# HAM CR 96 3.92-SIDEWALK

THE PROJECT INVOLVES THE CONSTRUCTION OF NEW SIDEWALKS ON BOTH SIDES OF SPRINGDALE ROAD FROM POOLE ROAD TO YELLOWWOOD DRIVE.

STAGE 3 SUBMITTAL - JULY 23, 2023

TYPICAL SECTION - SPRINGDALE ROAD

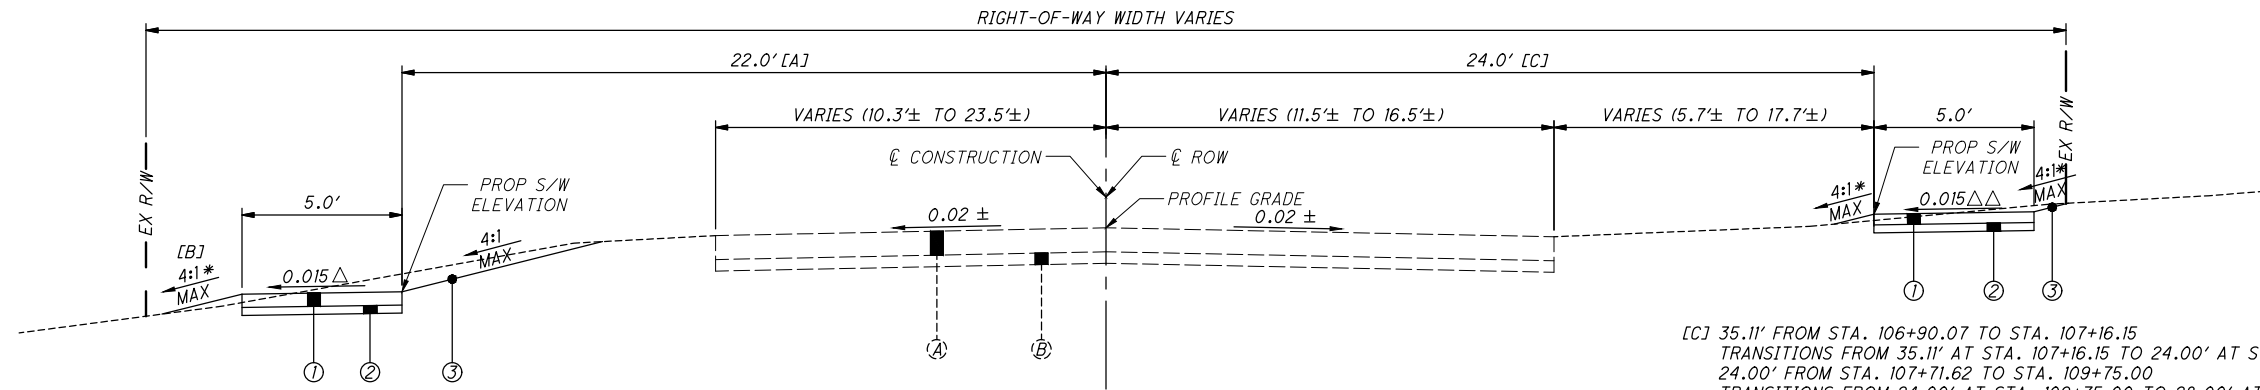
Add Item 204 subgrade compaction for sidewalks.

△△ SIDEWALK CROSS SLOPE VARIES AS DETAILED BELOW

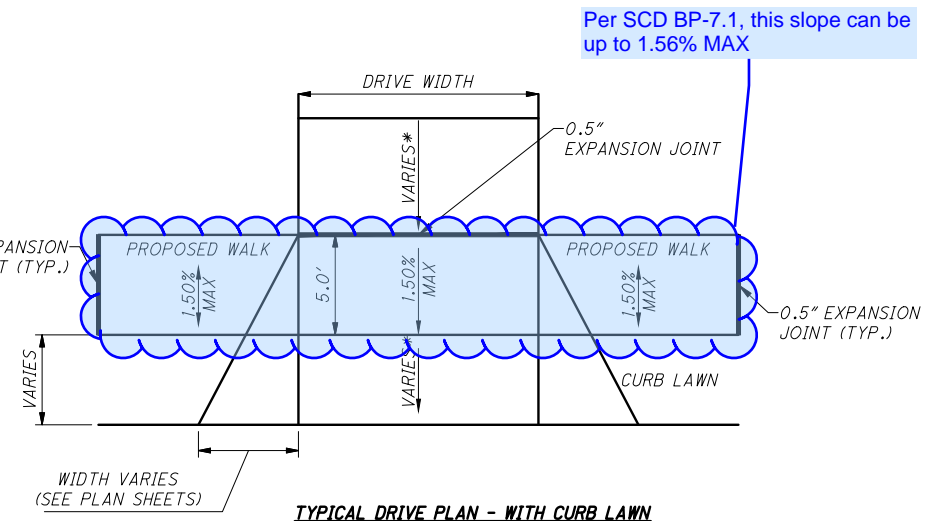
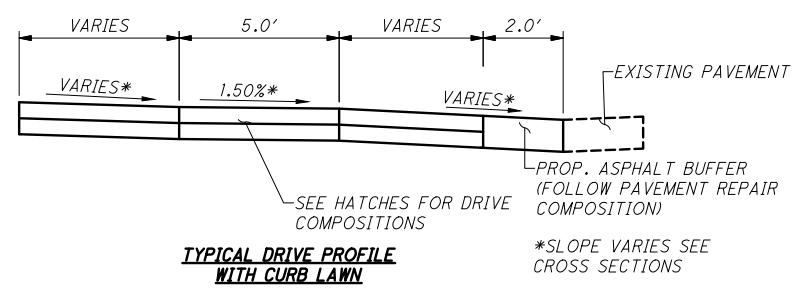
Per SCD BP-7.1, this slope can be up to 1.56% MAX

**PLAN AND PROFILE - SPRINGDALE ROAD**  
STA. 100+00 to STA. 105+00

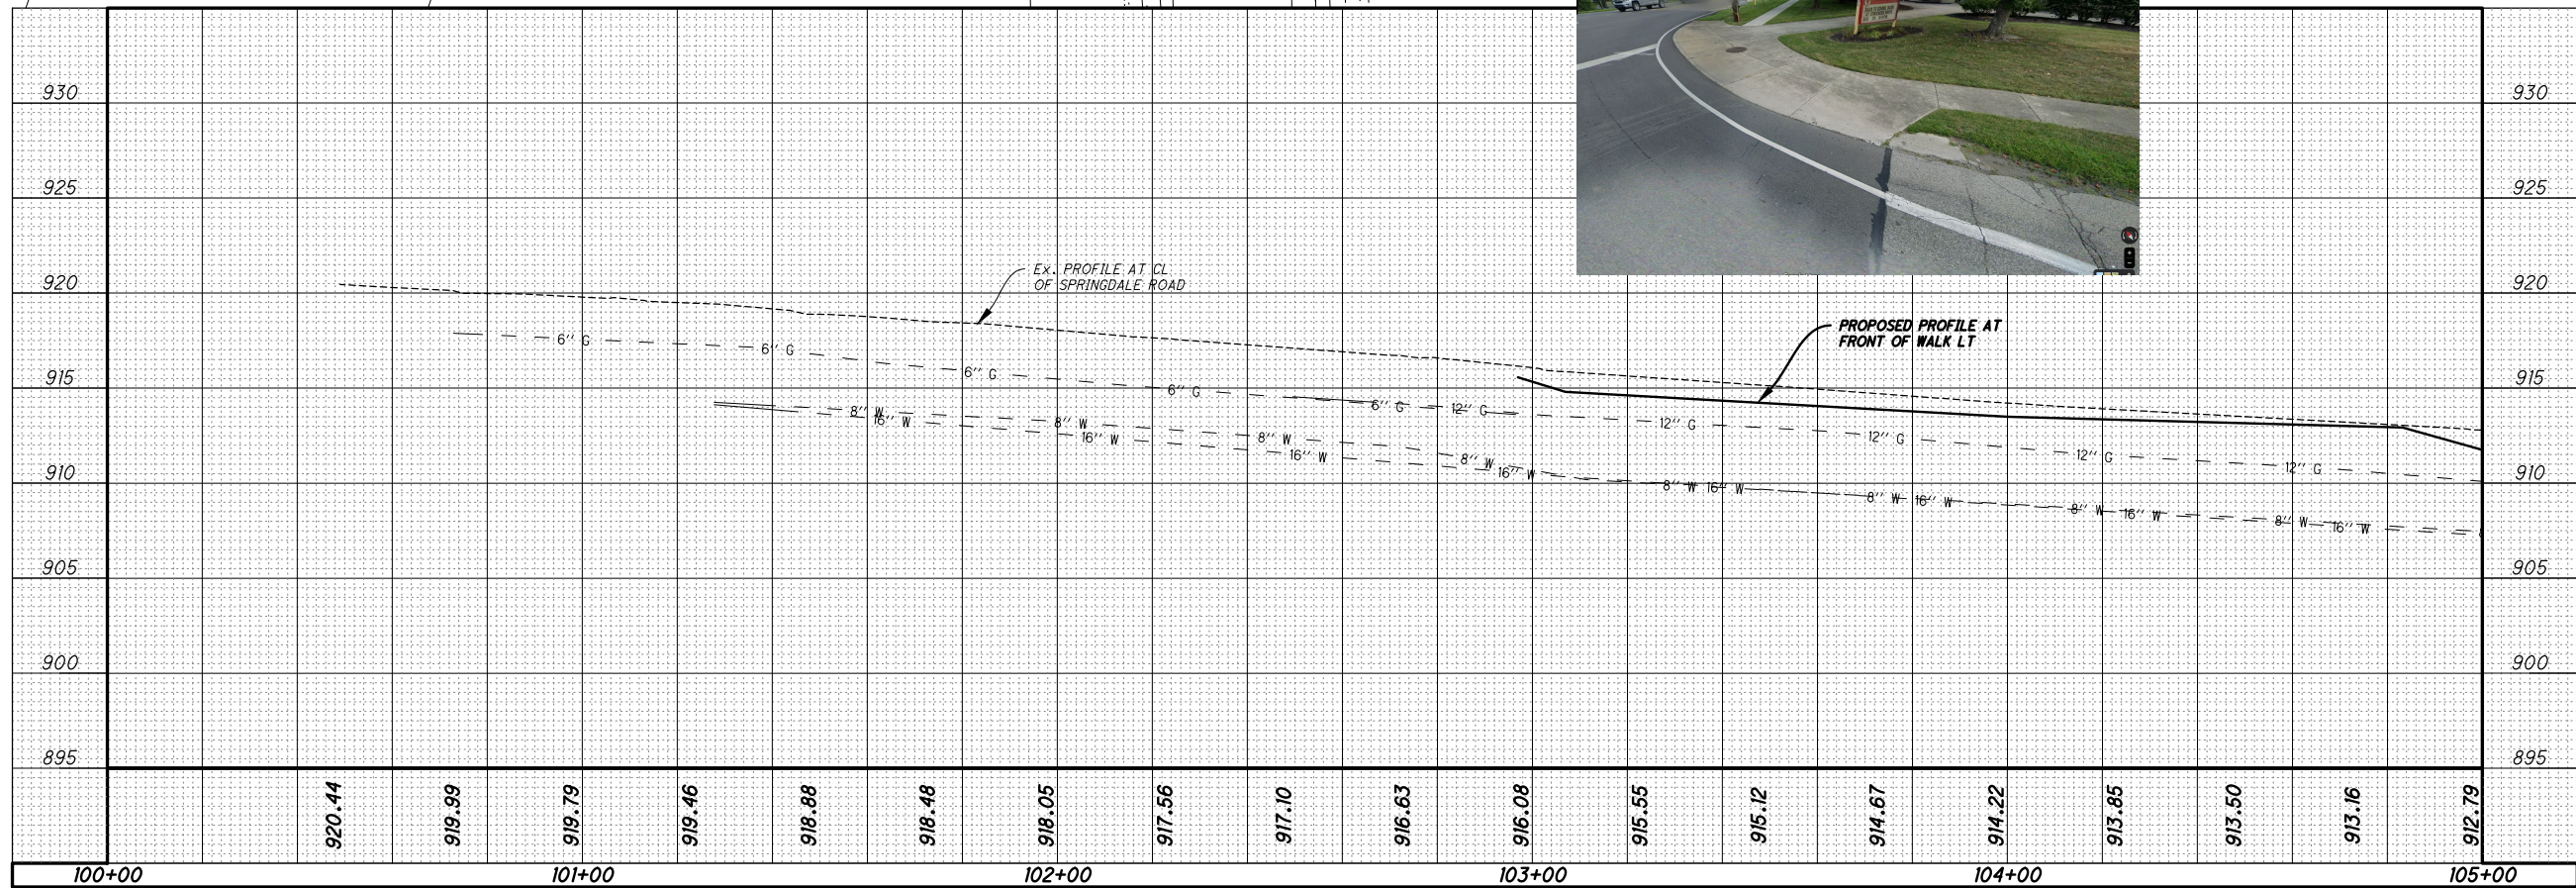
add the gold hatching for the

Where is this being relocated to?  
Is the anchor staying within the R/W?

This proposed grass area will become damaged and rutted by turning vehicles. Consider installing curb around the radius. Would have to add some pavement repair quantity as well.

**PLAN AND PROFILE - SPRINGDALE ROAD**  
STA. 105+00 to STA. 110+00

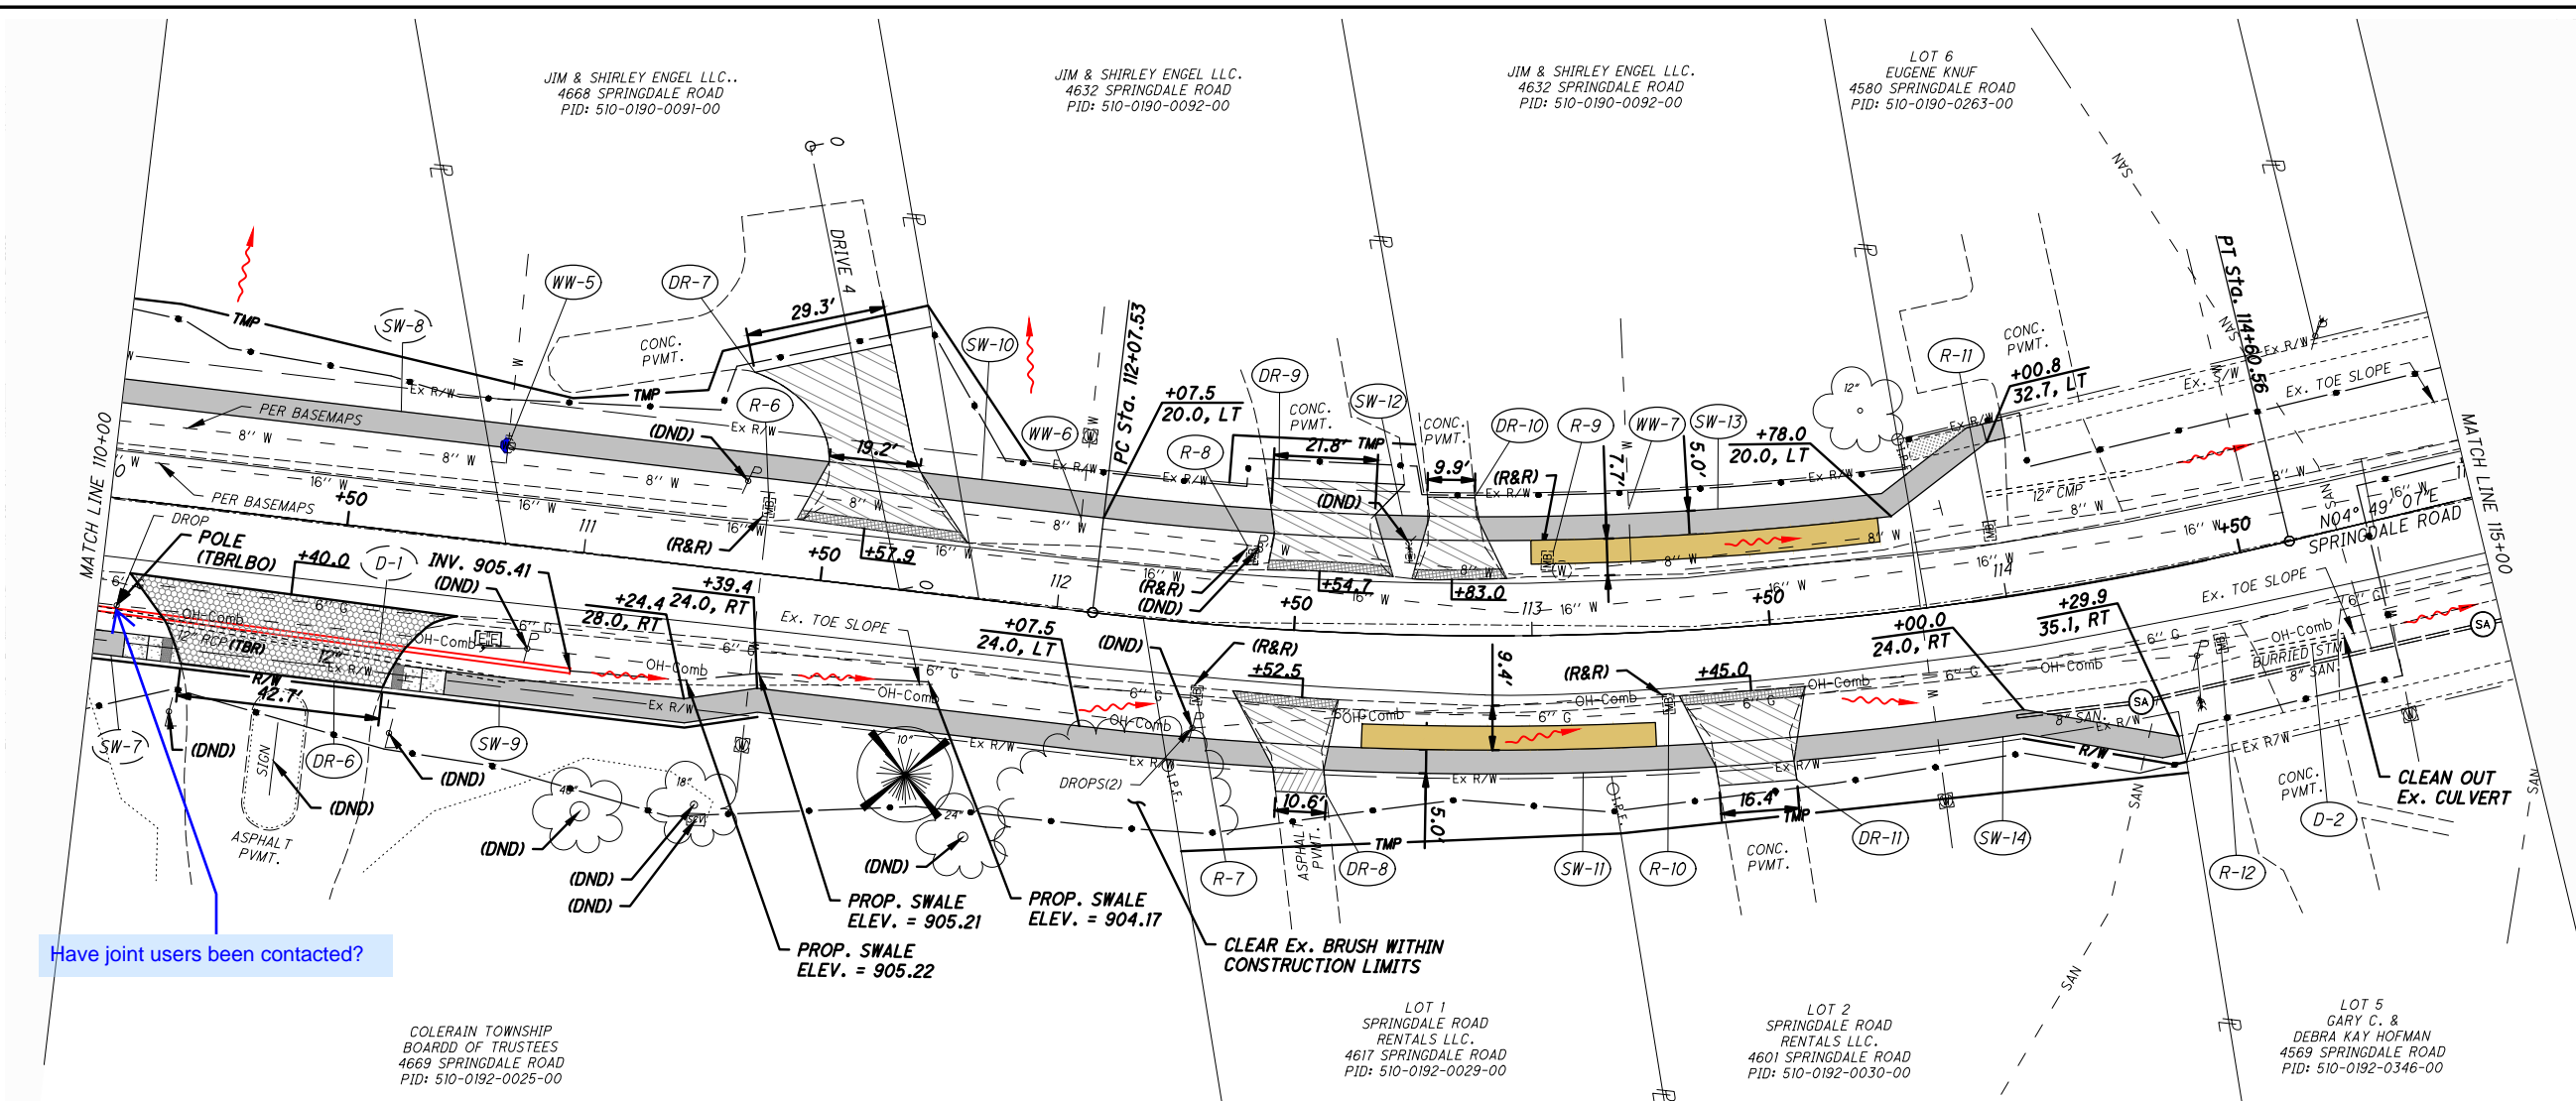
Have joint users been contacted?

**CROSS SECTIONS - SPRINGDALE ROAD  
STA. 121+41.40 TO STA. 122+50**

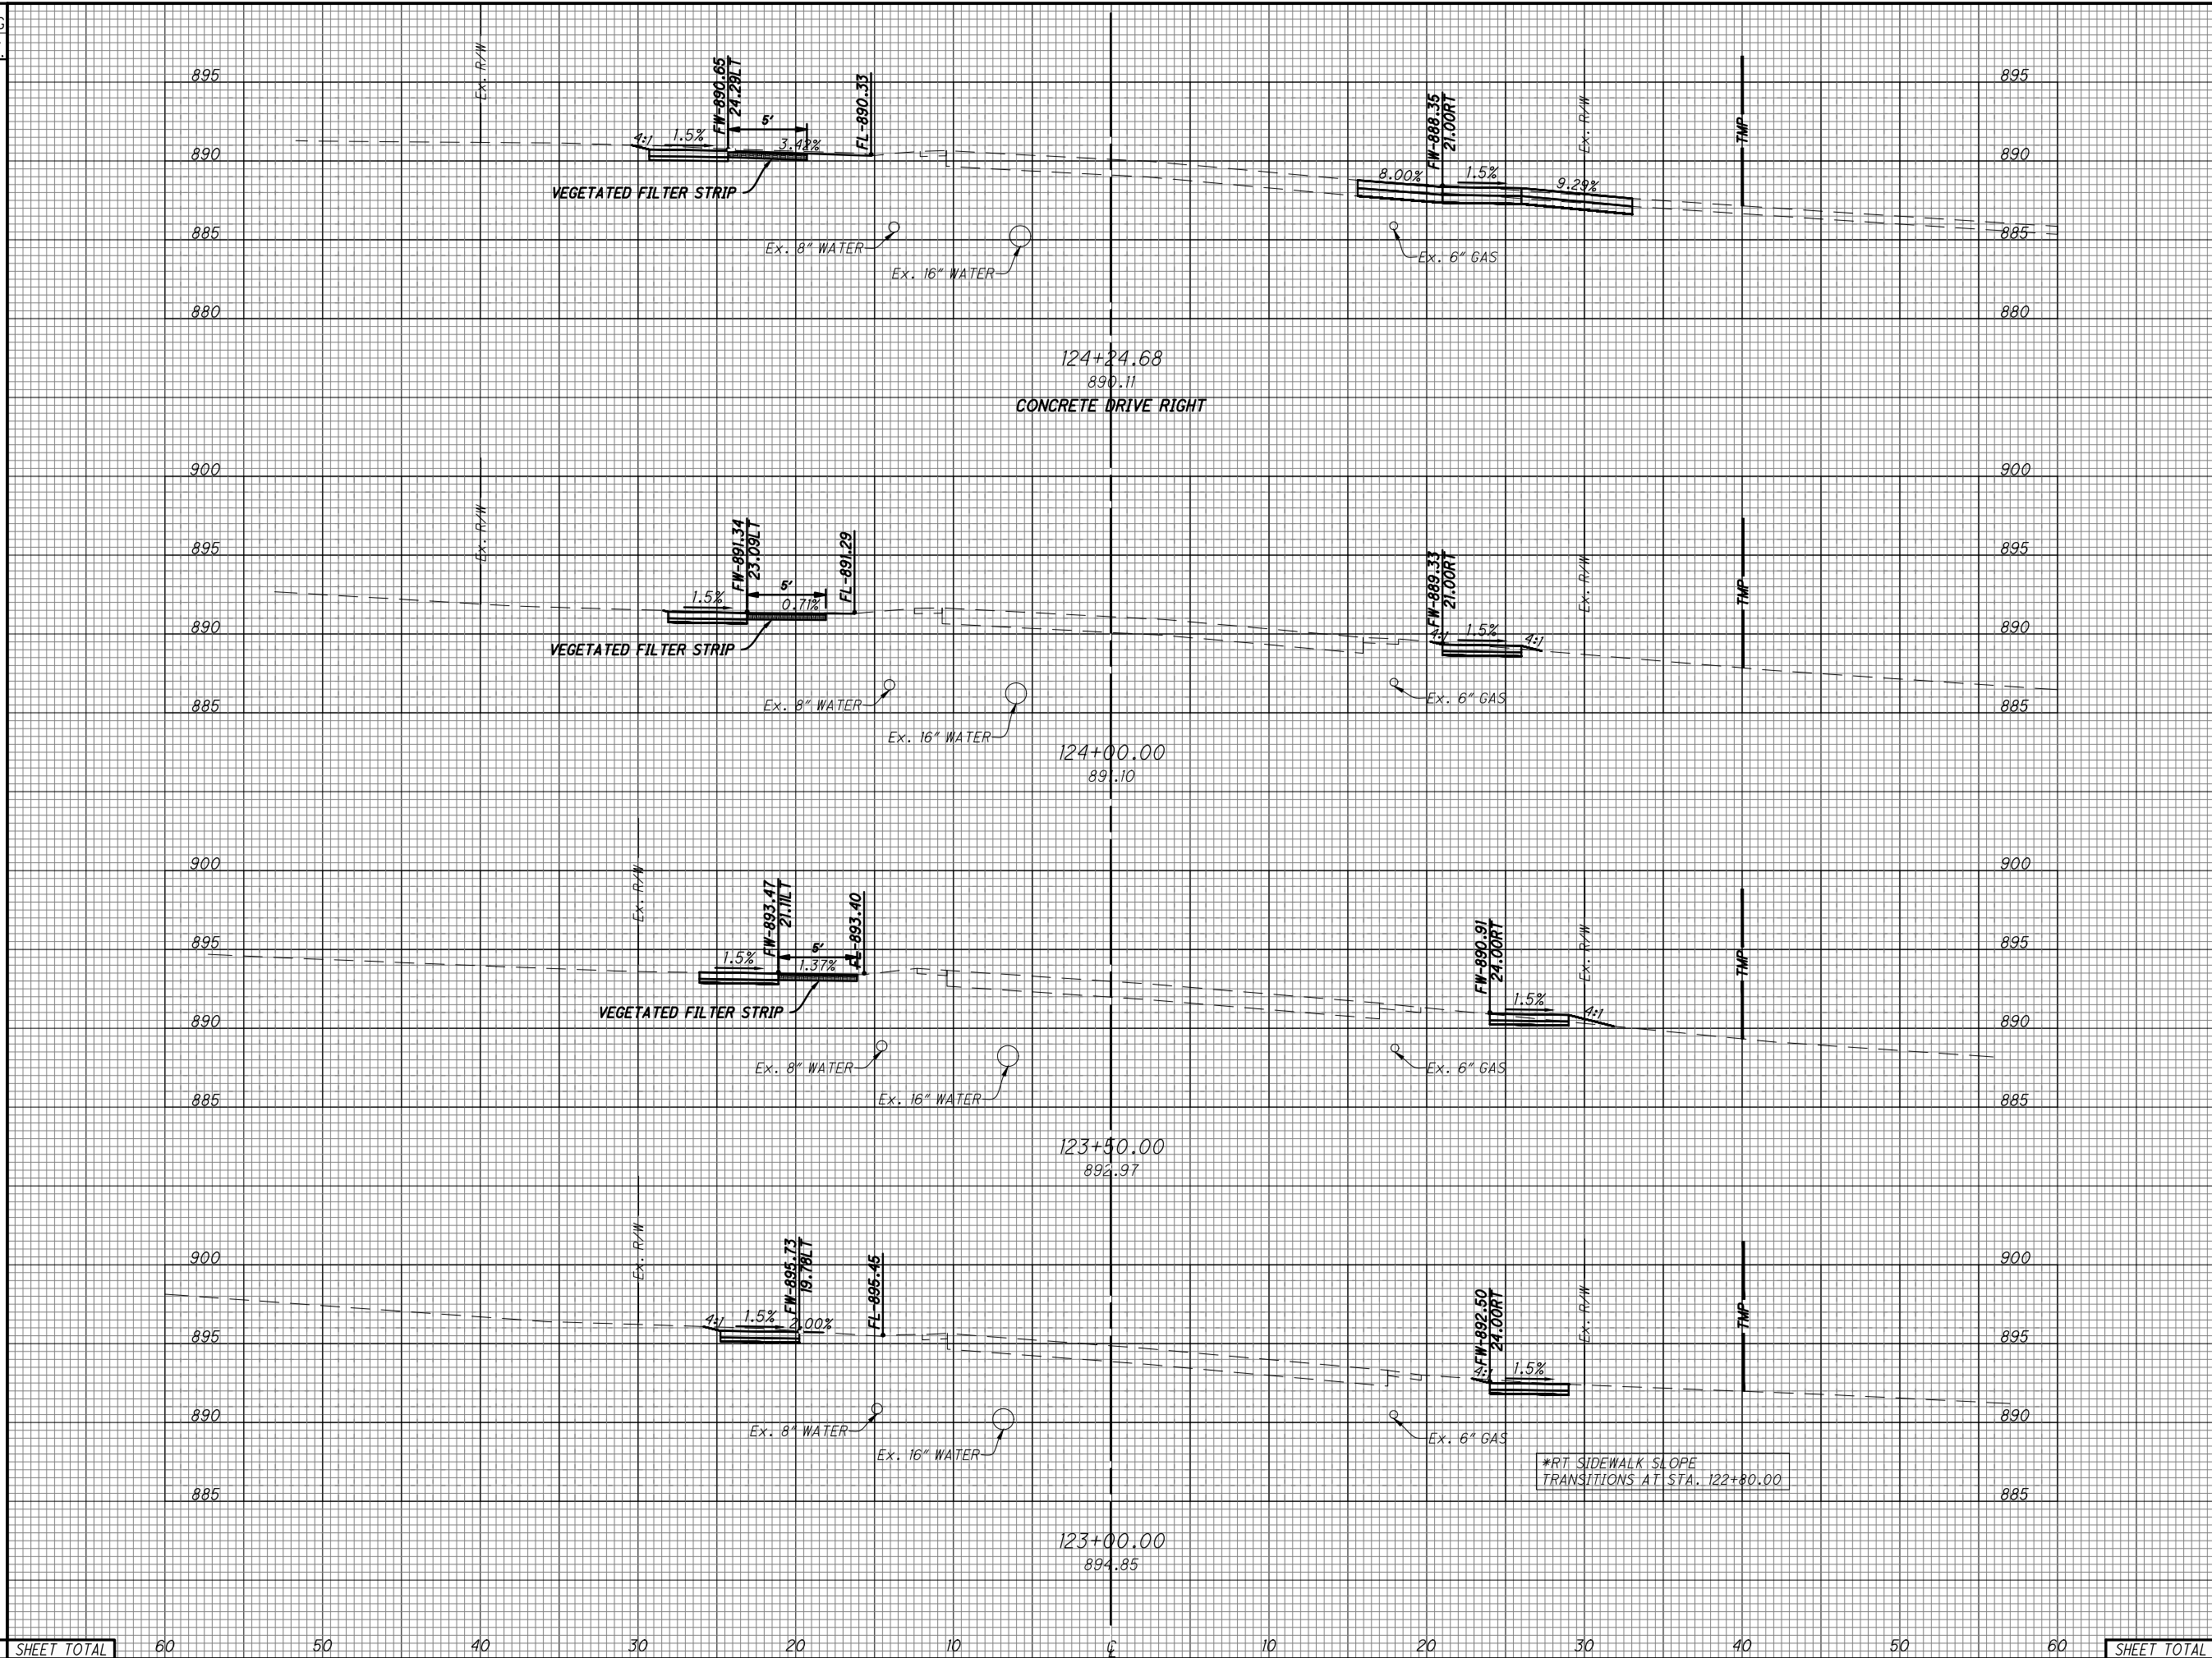
? pipe should not be interfering with new pavement
